TECHNICAL BULLETIN No. 005-2011**27/06/2011****Model: DRD X-TREM 50 2T'10, DRD RACING 50 2T'10, GPR 50 2T, GPR 125 4T****Subject: Transmission and tightening torque clearance update.**

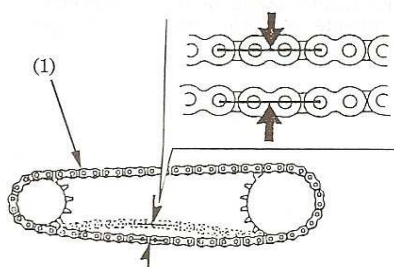
Please note that it is important to correctly fix the transmission chain during predelivery and during following regular maintenance (see use and maintenance manual), as well as to correctly tighten the rear wheel axle nut and the chain tensioner, whose values are indicated in the workshop manual, in order to prevent that the transmission chain exits and then breaks.

Please note that it was included a spring washer D8, Ref.: **00000033080** in the fixing screw of the wheel tensor plate, to assure the pressure and keep the tightening torque, on models DRD Racing 50 2T 2010, GPR 50 2T and GPR 125 4T.

Model	Chain clearance
DRD X-TREM 50 2T'10	From 40 to 45 mm
DRD RACING 50 2T'10	From 30 to 35 mm
GPR 50 2T	From 20 to 25 mm
GPR 125 4T	From 40 to 45 mm

Model	Rear wheel axle	Screw / tensor nut
DRD X-TREM 50 2T'10	7- 8 kg.m (70-80N.m)	0.2 - 0.4 kg.m (2 - 4 N.m)
DRD RACING 50 2T'10	7- 8 kg.m (70-80N.m)	1.5 - 1.9 kg.m (15-19N.m)
GPR 50 2T	7- 8 kg.m (70-80N.m)	1.5 - 1.9 kg.m (15-19N.m)
GPR 125 4T	7- 8 kg.m (70-80N.m)	1.5 - 1.9 kg.m (15-19N.m)

- Loosen the rear wheel axle nut.
- If the chain has excessive clearance, tighten the screws fixing the wheel tensors, with the same number of turns for each side up to obtain the specified tension value.
- Make sure that the alignment signs of the wheel are correct. In case of doubt about the correct alignment of the wheel, check with a ruler.
- Tighten the wheel axle nut to the specified value.
- Tighten the chain tensioner screw to the specified value.
